Palatka Pulp and Paper Operations
Consumer Products Division

**Re: Project No. 1070005-038-AC/PSD-FL-380
EU no. 014 – No. 4 Power Boiler
Notice of Permanent Shutdown**

**Re: Project No. 1070005-038-AC PSD-FL-380
Modification of the No. 4 Recovery Boiler, No. 4 Lime Kiln and No. 4 Combination
Boiler
Response to Request for Additional Information No. 3**

RE: Draft Air Permit No. PSD-FL-380
Project No. 1070005-038-AC
Georgia-Pacific Consumer Products LLC – Palatka Mill
Modification of No. 5 Power Boiler, No. 4 Lime Kiln, No. 4 Recovery Boiler, and
No. 4 Multiple Effect Evaporators

**FIGURE 1
SIMPLIFIED PROCESS FLOW DIAGRAM FOR
LVHC AND HVLC EXHAUST GASES**

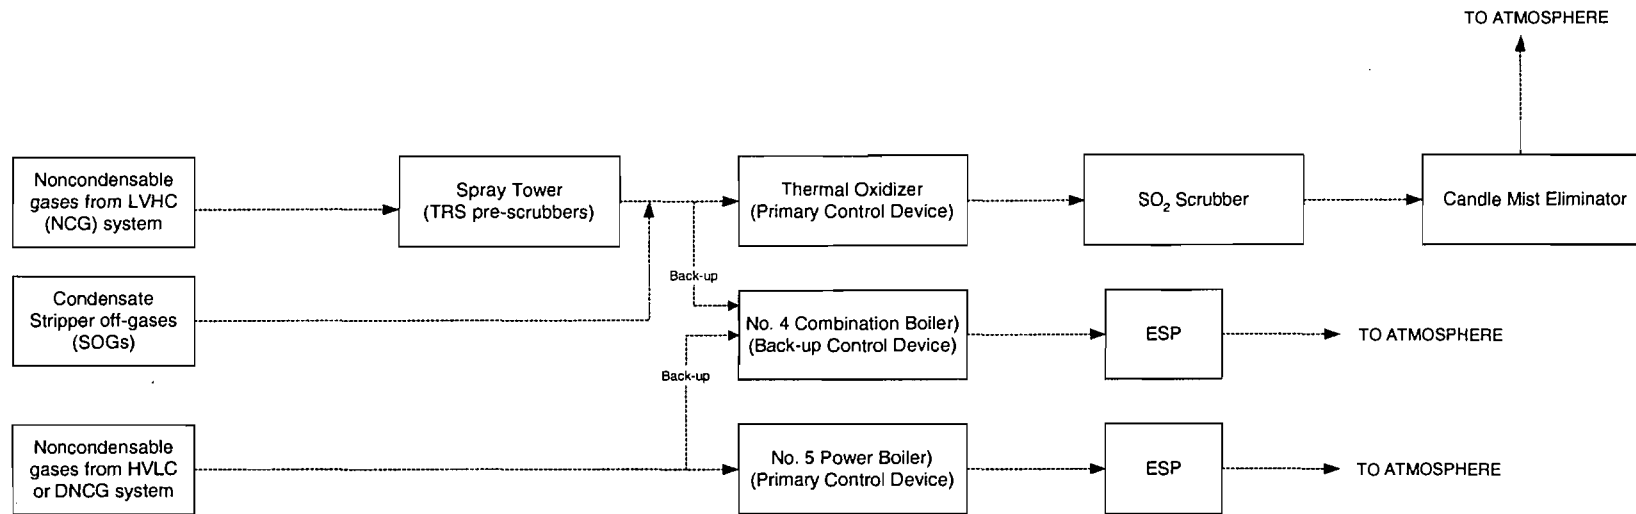
Answer: A simplified PFD has been prepared and is attached as Figure 1.

Updated Process Flow Diagram – No. 4 CB – (GP-EU1-I1)

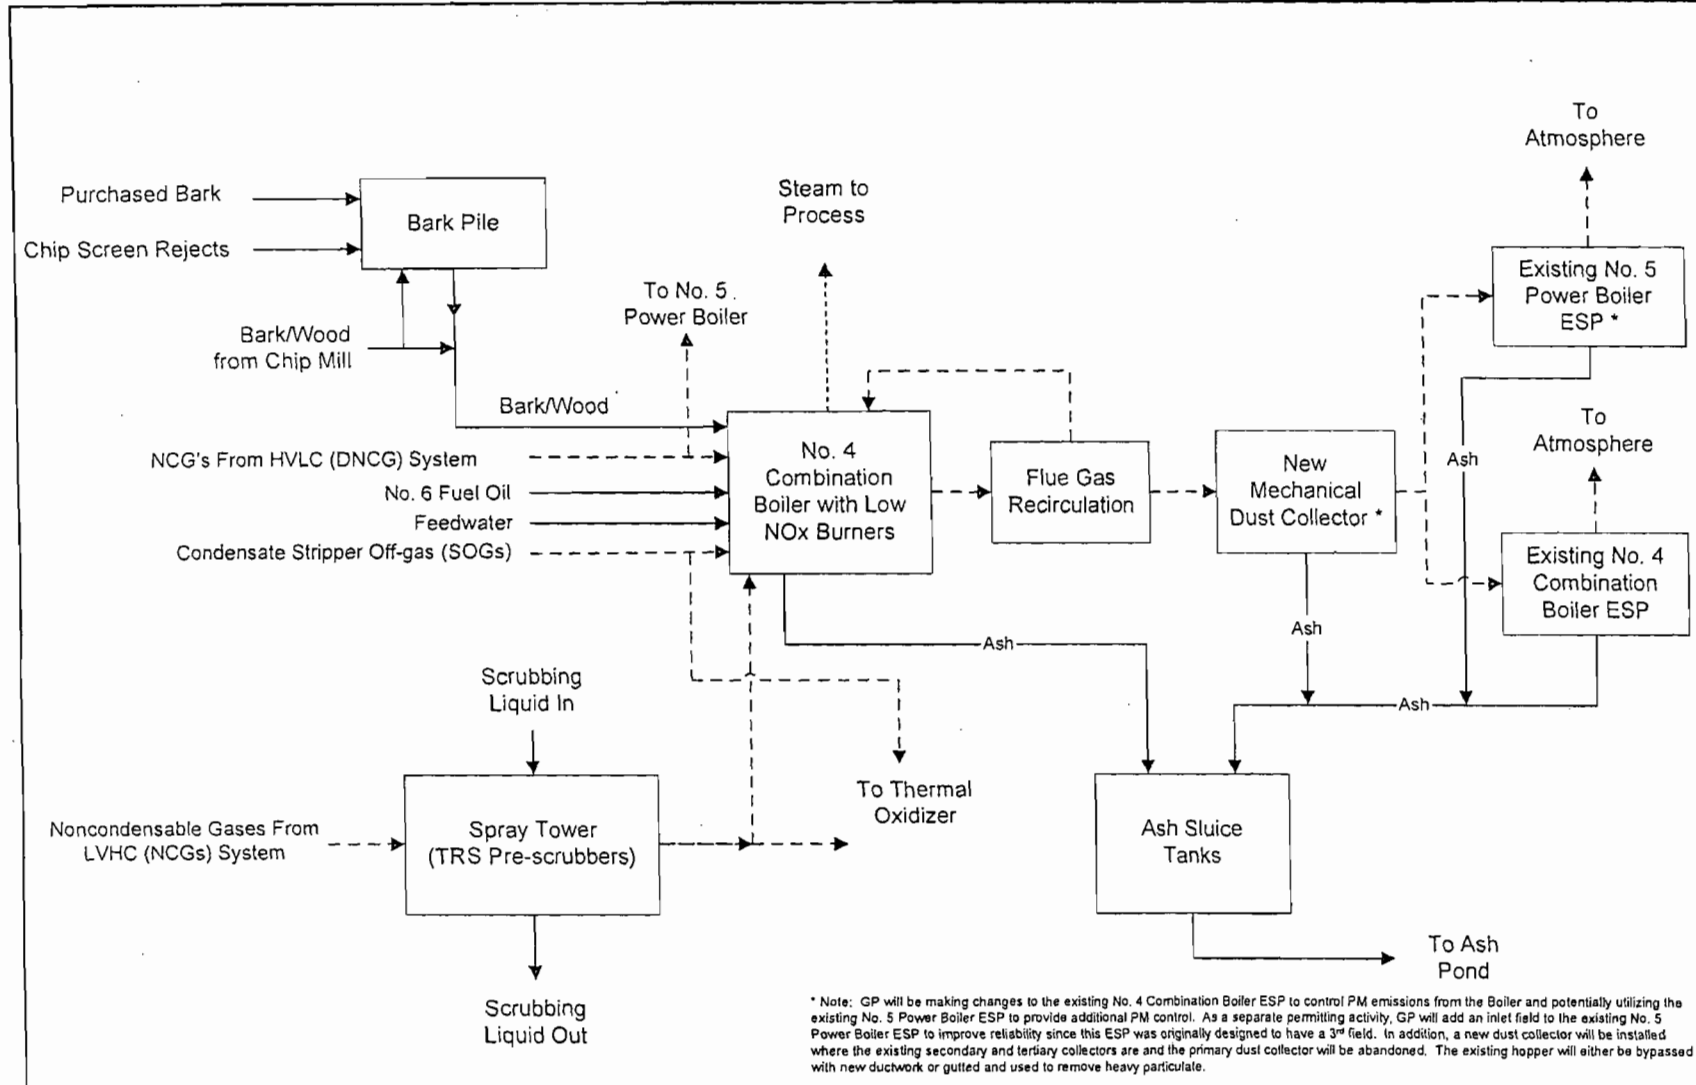
ATTACHMENT C (Q-13)
